FIRE SAFETY INSPECTION REPORT

Nemrac Design Ltd.

Plot: A-172, BSCIC I/A, Shashongaon Fatullah, Narayanganj

Date: 08 December 2019

F-2 Egress

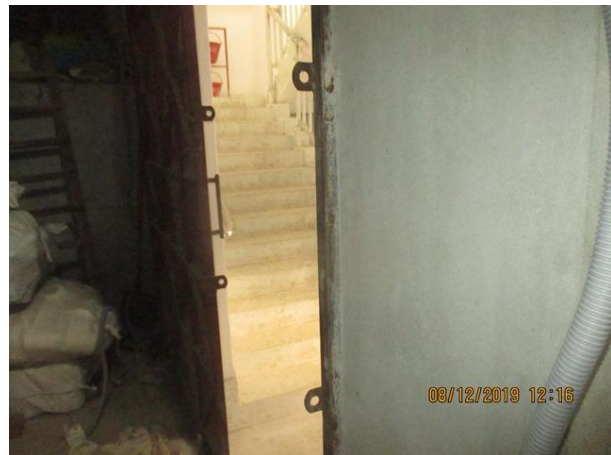
Egress gates on the all floor with locking features are provided at all exits & exit discharge. (Both building)

Remove locking features from all egress gates.

If locks are required for security reasons, utilize special door locking features complying with ACCORD standard 6.8.2.
